AGENDA
FARRAGUT MUNICIPAL PLANNING COMMISSION

September 15, 2016
7:00 p.m. Farragut Town Hall

**MINUTES
FARRAGUT MUNICIPAL PLANNING COMMISSION**

REPORT TO THE FARRAGUT MUNICIPAL PLANNING COMMISSION

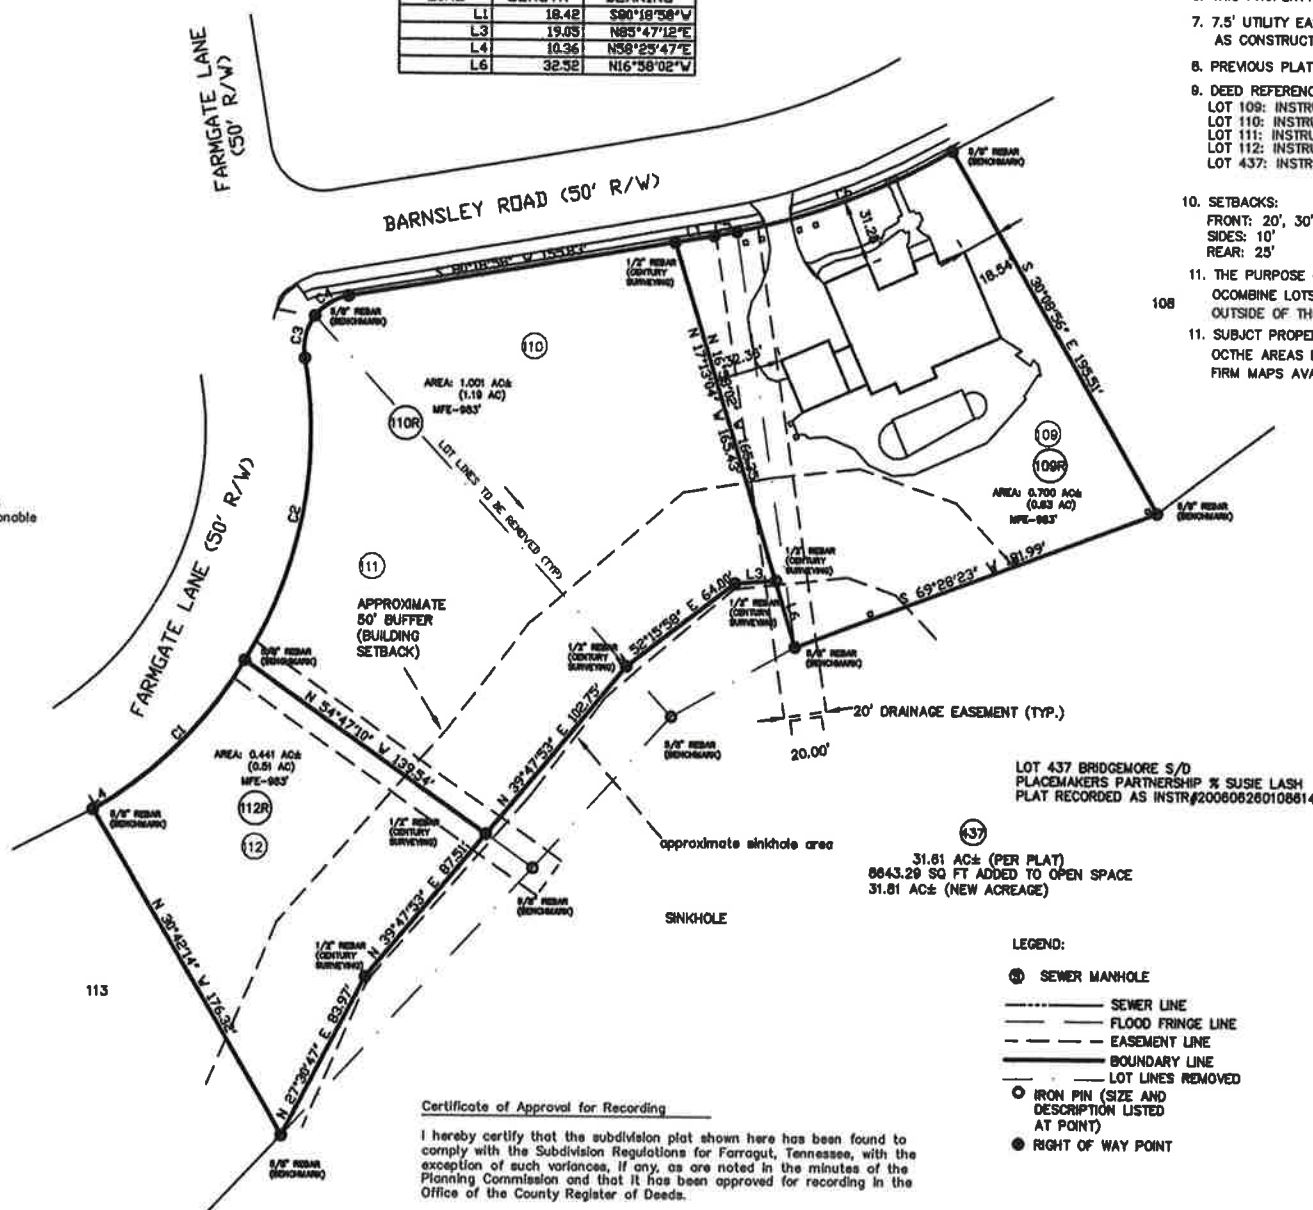
- 4) The developer will need to be aware of the need to update their overall concept plan so it is consistent with this modification;
- 5) Please include the deed references for Lot 437 in Note #9;

- 6) Please include MFE's for Lots 110R and 112R – these were listed on the Phase I plat;
- 7) The 15 foot drainage easement is actually a 20 foot drainage easement. Please correct and re-label;

- 8) Please label the sinkhole lip elevation and the 50 foot building setback from the sinkhole lip elevation;
- 9) Please include on the plat drawing, for Lot 437, the instrument number, map, cabinet, slide, property owner, and subdivision;

- 10) Please list Lot 437 instead of common area where the owner information is listed for such lot. Does the Bridgemore HOA own this lot?
- 11) Please add a title to the release of easements certification block;

- 12) Please replace County Highway Dept with Town Engineer on the Release of Easement certificate;

Briarstone Subdivision Phase 4
Town of Farragut, Tennessee
District 6, Knox County, Tennessee

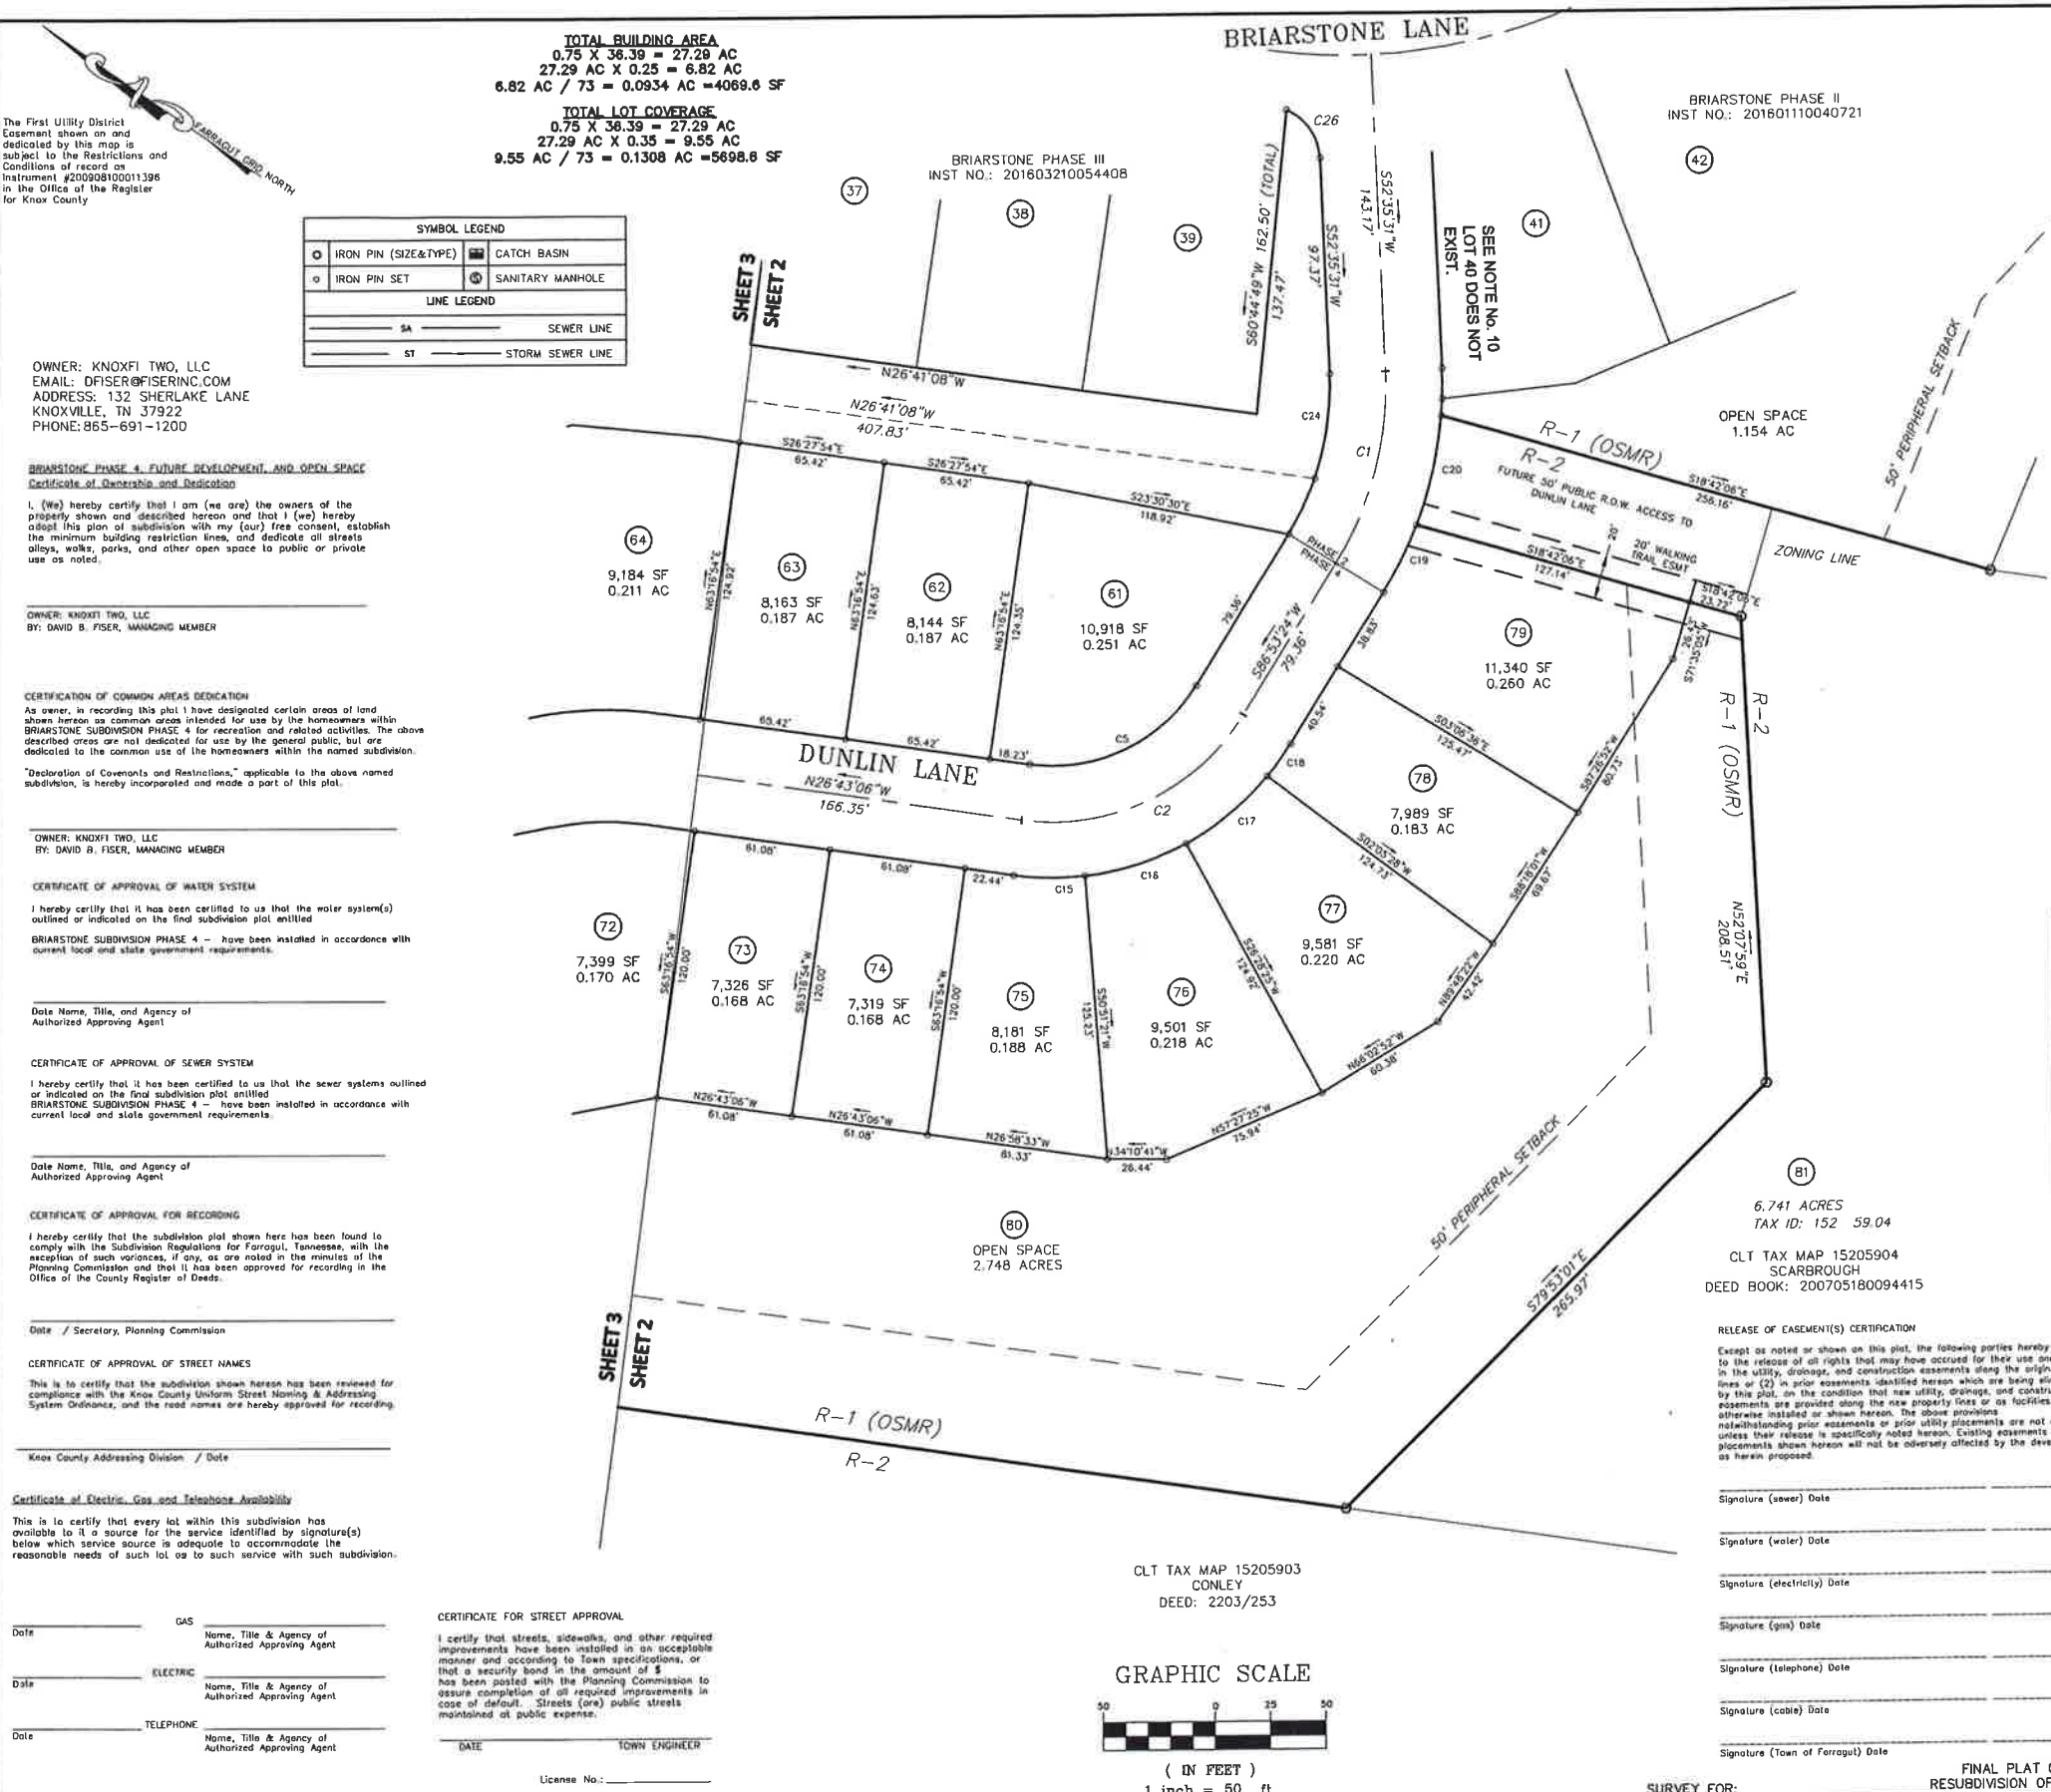
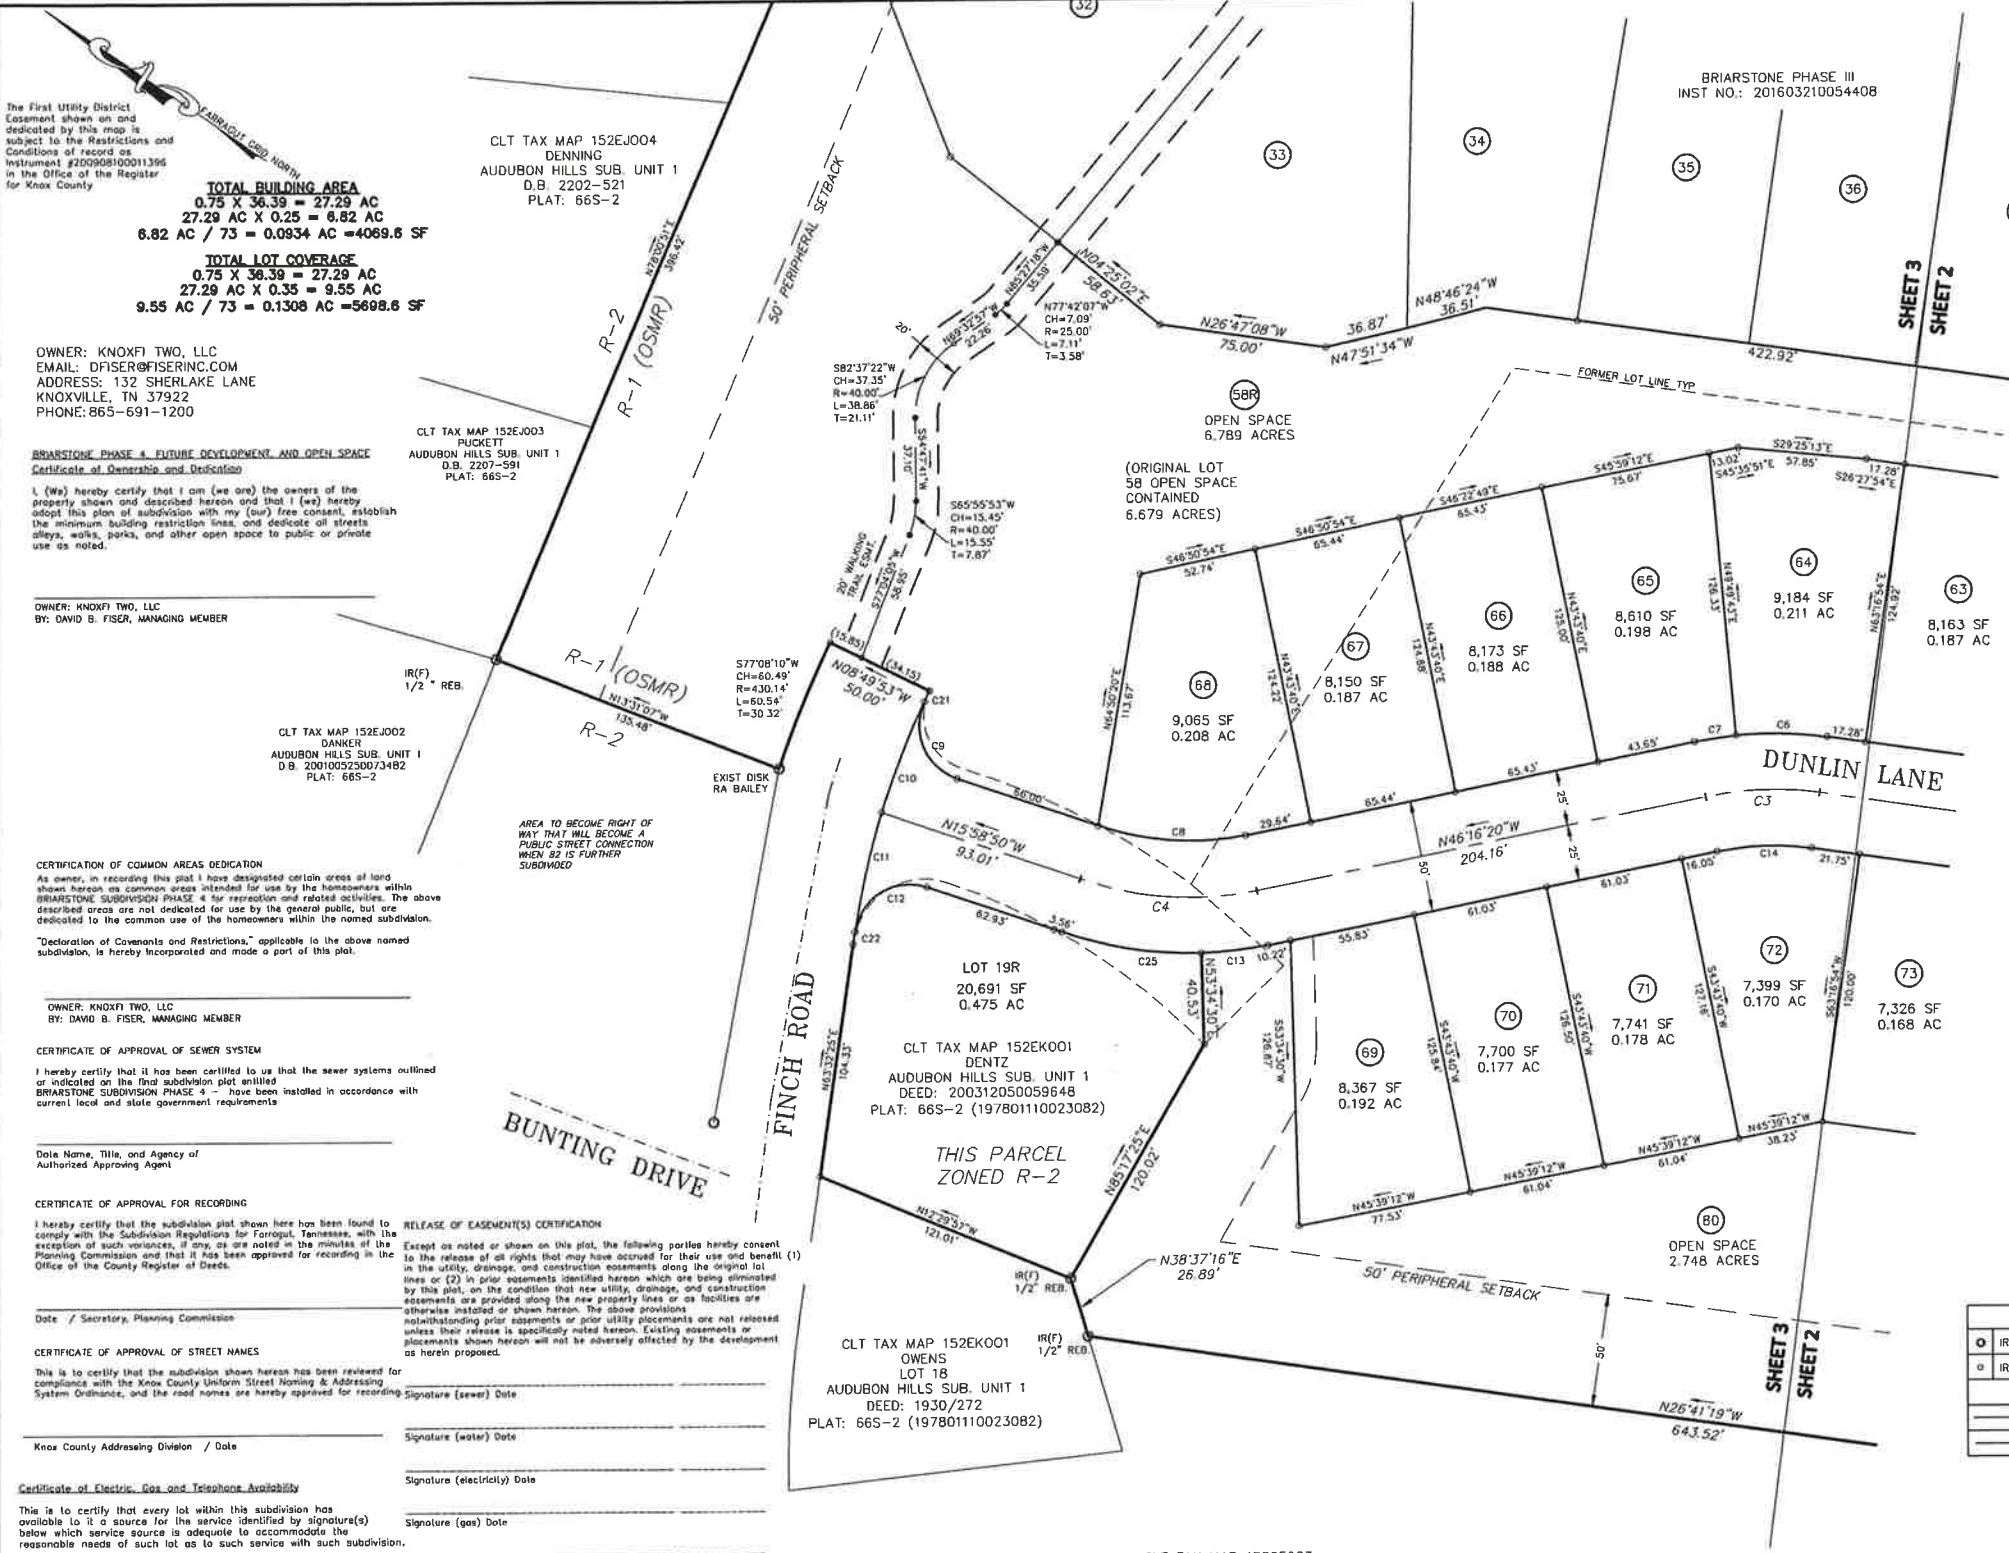
1. Please correct the acreage, number of lots, and phase reference for the total lots in the summary listed at the top left portion of the plat;
2. Please correct the purpose of the plat note to include that this will add one open space lot – Lot 80;

7. Please omit Road B. This is now Dunlin Lane;
8. Please reference the correct phase in all of the certifications and elsewhere on the plat;
9. Please specifically address in a plat note that Lot 80 is to be owned and maintained by the Briarstone Homeowners Association;

10. Please add a line for the Knox County Addressing signature;
11. Lot 58 is being changed from the recorded lot from Phase III. Please make this Lot 58R and include the previous lot number and acreage in parentheses;

12. Please include the flood certification as a numbered note. This starts out "Subject property is located in Flood Zone "X", being outside....."
13. Please coordinate with the staff on the planting of the required four (4) two (2) inch caliper replacement trees that will be needed for the hackberry tree removed;

14. Please provide an update to the covenants prior to the issuance of a building permit;
15. Please correct the zoning. The Scarbrough property is zoned R-2;
